Parks Forestry & Recreation
Capital Projects Design & Delivery

ADDENDUM NO. 2

ROSTER RFSQ NO.: 3907-19-5003
PROJECT NAME: LOWER HILLSIDE (HIGH PARK) WASHROOM
WORK ASSIGNMENT NUMBER: 24-PFR-CAP-GC-003

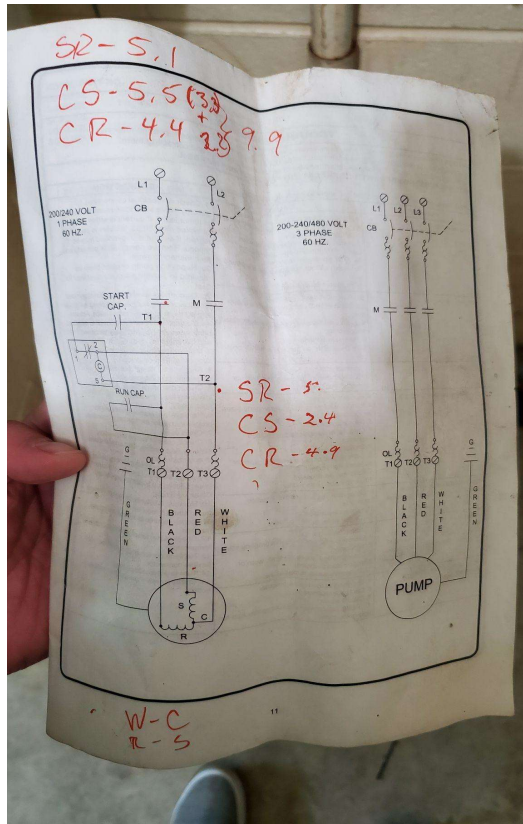
4.2 Site photos of sump pump pit location

4.2 Please see attached photos below for site photos of sump pump location
